The enclosed Revised Traffic Operational Analysis (TOA) review letter for the proposed **Lincoln Center** (Tax Parcel: 10-033.00-040) mixed-use development has been completed under the responsible charge of a registered professional engineer whose firm is authorized to work in the State of Delaware. They have found the TOA to conform to DelDOT's Development Coordination Manual and other accepted practices and procedures for such studies. DelDOT accepts this letter and concurs with the recommendations. The letter has been revised to reflect changes to the development's change in land use and access configuration. If you have any questions concerning this letter or the enclosed review letter, please contact me at Annamaria.Furmato@delaware.gov.

RE: Agreement No. 1945F
Project Number – T202369005
Traffic Impact Study Services
Task 11-5A – Lincoln Center TOA

Johnson, Mirmiran, and Thompson (JMT) has completed a review of the Traffic Operational Analysis (TOA) for the Lincoln Center development, which was prepared by Landmark Science & Engineering, dated April 2022, last revised September 2022. This review was assigned as Task Number 11-5A. The report is prepared in a manner generally

Lincoln Center – Updated Land Uses

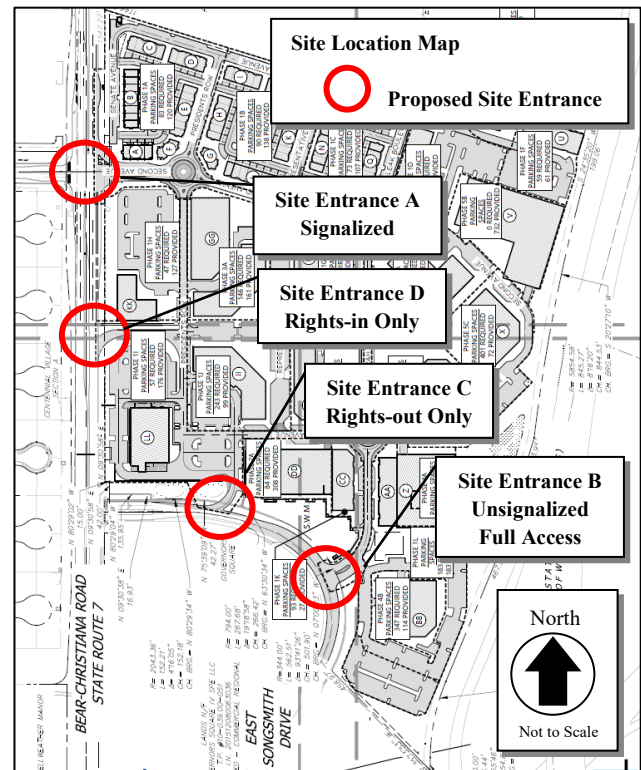
A Final TOA review letter was issued on May 1, 2023 for the development proposed in the September 2022 TOA. Since the issuance of the May 1, 2023 Final TOA review letter, the proposed development has been updated to include 508 units of mid-rise multi-family housing, a 110-room hotel, a 10,000 square-foot daycare, 499,863 square feet of general office space, 196,862 square feet of shopping center space, and a 5,000 square foot high turn-over sit-down restaurant. Additionally, a rights-in only access is proposed along Delaware Route 7, approximately 500 feet north of Site Entrance A and a rights-out access is proposed along E. Songsmith Drive. Concept Plans depicting the previous and latest layouts are shown on Page 13.
